National Transportation Safety Board

Safety Recommendation

Date: February 23, 2012

In reply refer to: A-12-1 through -6

Figure 1. Diagram of a 737 PSU and overhead bin installation.

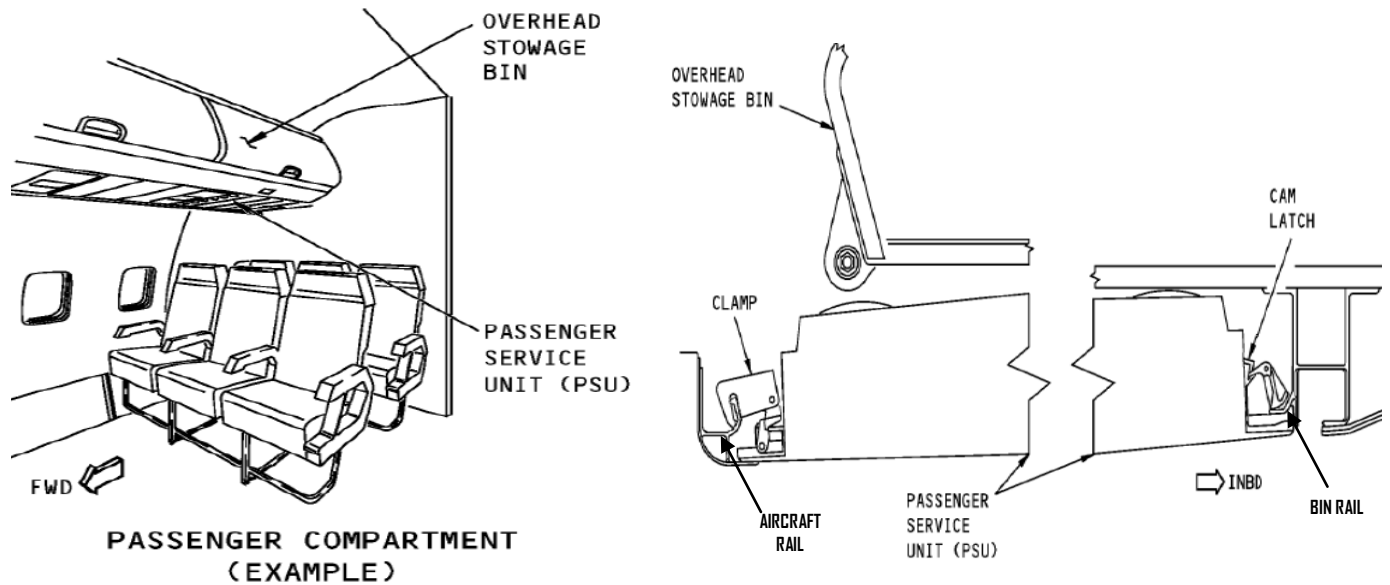
For all of the Boeing 737 accidents cited, the overhead bin and PSU installations were of common design and manufactured, installed, and inspected per Boeing specifications. Two polymer plastic clamps attach the outboard side of the PSU to the aircraft rail and fuselage side wall; two polymer cam latch mechanisms attach the inboard side of the PSU to the bin rail. The bin rail is fastened to the underside of the overhead bin (see figure 1). A maintenance lanyard is connected to the inboard side of the PSU to allow it to hang from the overhead bin for ease of

Because these PSU attachment points cannot withstand the substantial forces created by the relative motion of the structure, an alternative approach is necessary to prevent injury caused by PSUs that become separated from their attachments. For example, fittings that can accommodate accident sequences with considerable relative motions of structure or mechanisms that provide for capture of a separated PSU, assuming that the unit could separate, may provide an adequate level of safety. Whatever approach is taken, designers should plan to prevent released PSUs from striking occupants in survivable accident scenarios. Therefore, the NTSB recommends that the FAA require that the installation design for overhead bins and PSUs manufactured by Boeing and installed in Boeing 737NG series airplanes be modified so that the PSUs remain attached to the bins or are captured in a safe manner during survivable accidents. Because other manufacturers may have similar overhead bin and PSU designs with the same

Require that the installation design for overhead bins and passenger service units (PSU) manufactured by Boeing and installed in Boeing 737NG series airplanes be modified so that the PSUs remain attached to the bins or are captured in a safe manner during survivable accidents. (A-12-2)

Figure 2. Photographs of a dislodged PSU, showing the maintenance lanyard and fractured outboard clamps.

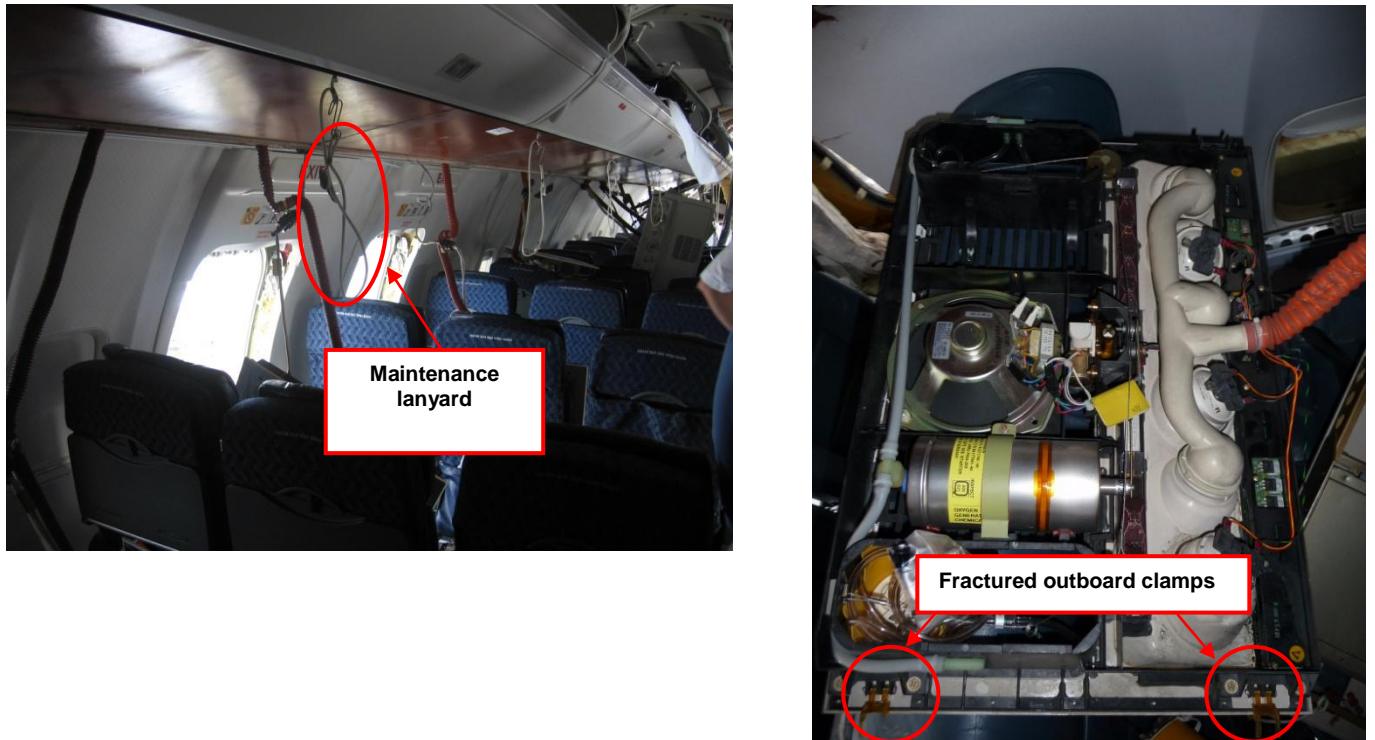
access when conducting maintenance (see figure 2). The overhead bin is suspended from the fuselage ceiling and side walls with the use of tie rods (labeled (A), (B), (C), and 9 g in figure 3).¹¹

Based on this information, it was determined that when the (C) tie rods broke during the accident sequences, overhead bins (and attached bin rails) were allowed to articulate inboard from their upper attachment points to the fuselage, causing increasing separation between the aircraft rails and bin rails. As the bin rails and aircraft rails moved farther apart, the resulting load from the bins was passed on to the PSU outboard clamps causing them to fracture. As the released PSUs dropped, the maintenance lanyards separated from the PSUs during the fall.¹⁹

Modify the design and test requirements for the attachment points of passenger service units to account for the higher localized loading that results from the relative motion of the attachment structure. (A-12-1)

Figure 5. Photographs showing broken negative-*g* strap attachment bracket on American Airlines flight 331 captain's seat.

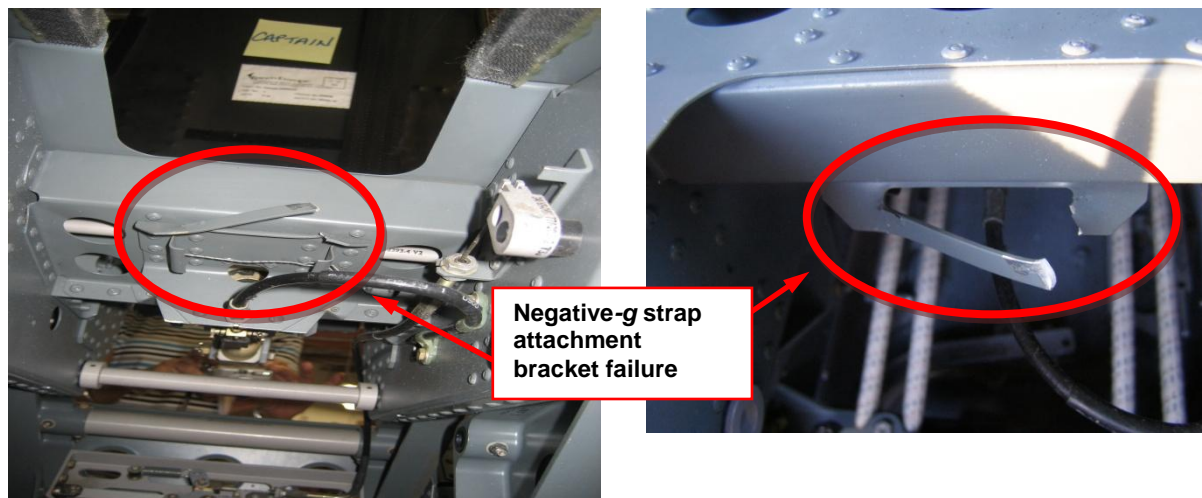
Ipeco, Inc. designed, tested, and manufactured the seats that were installed at the captain and first officer positions in both airplanes; however, the negative-*g* attachment brackets were of two different manufacturer designs. One bracket, designed by Ipeco, consists of 0.063-inch thick sheet aluminum that is riveted to the seat. A loop stitched onto the strap is inserted through the bracket, and a rod is inserted through the loop behind the bracket to keep the strap in place. This design was installed at all three crew positions where the bracket failed. The other bracket, designed by AmSafe Aviation, consists of 0.093-inch thick aluminum that is bolted to the seat, and the strap is looped through the bracket then stitched. The thicker bracket, used on the first officer's seat on flight 331, did not fail.

As part of the investigation of the flight 331 accident, the strength of the negative-*g* attachment bracket was evaluated by the JCAA, NTSB, Ipeco, and a biomedical engineer from the FAA Civil Aerospace Medical Institute. The evaluation considered the captain's weight,²⁵ the occupant motion (an estimation of body contact points and relationship to injury causation, seated position, and seat belt loading),²⁶ and typical seat deformation observed during seat sled testing for certification purposes. During the evaluation, Ipeco determined that damage to the seat was comparable to damage observed for seats that passed the 16.7 *g* pulse used during sled testing. The evaluation determined, however, that the lateral loading to the occupant and seat, as well as multiple impacts during the accident sequence would likely induce additional loading into the bracket. As a result, the evaluation suggested that the forces imposed on the bracket during the accident were greater than demonstrated during certification testing, even though the overall loading to the seat appeared to be equivalent to the 16 *g* test requirements.

The NTSB recognizes that establishing the recommended test criteria and performance standards will take time. Given that three negative-*g* strap attachment brackets of the same design failed in two of the survivable accidents discussed, the NTSB is concerned that flight crew seats with the Ipeco-manufactured bracket remain on many in-service airplanes. Because of design considerations, Ipeco uses the thicker AmSafe bracket on new production seats; however, the NTSB believes that interim action is needed to address the thinner gauge brackets already in service. For survivable, multiple impact accidents such as those discussed, using a stronger bracket would likely provide a level of protection more consistent with that provided by the current seat designs. Therefore, the NTSB recommends that the FAA require that negative-*g* attachment brackets manufactured by Ipeco be retrofitted with stronger brackets.

Require that negative-g strap attachment brackets manufactured by Ipeco be retrofitted with stronger brackets. (A-12-6)
